SERVICE BULLETIN

M-859

SCREW TYPE FUEL CAP

Figure 1. FXR/FXRS Fuel Cap Identification

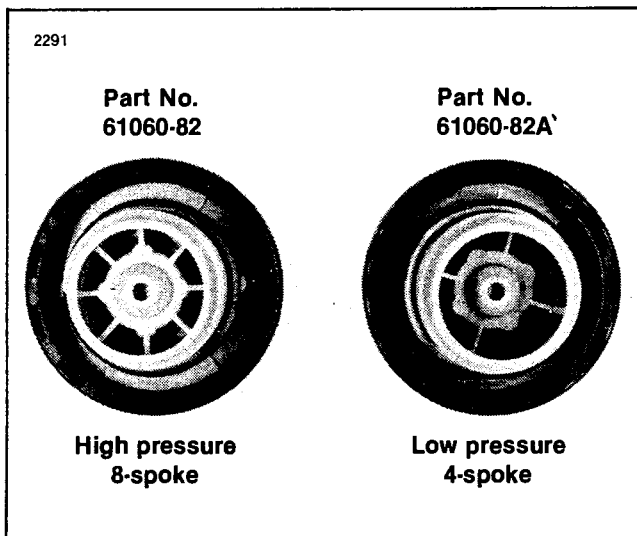
See Figure 1. The new low pressure cap for FXR/FXRS models can be identified by the number of spokes on the bottom inside of the cap. The new low pressure cap has four spokes.

Figure 2. Relief Vent

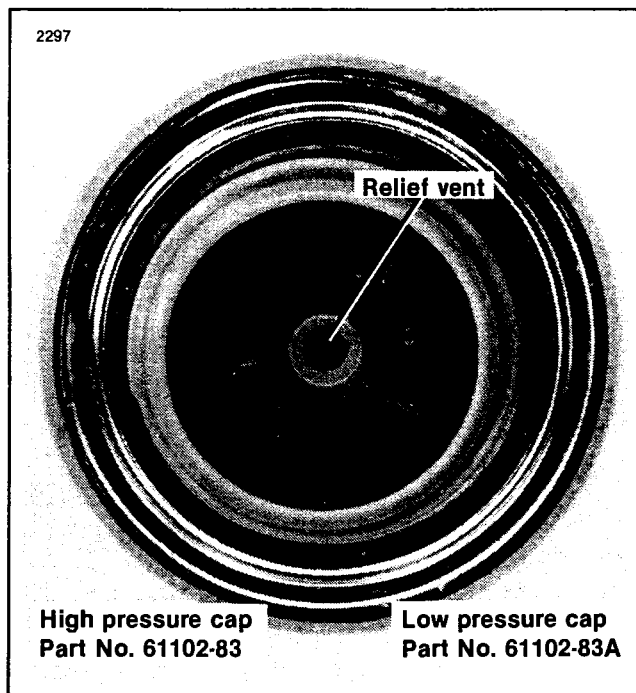
See Figure 2. For all other models, the new low pressure cap can be identified by pressing down on the relief vent with a pencil or ball point pen. The low pressure cap has a weaker spring beneath the relief vent and the dif-

ference in spring pressure can be felt.
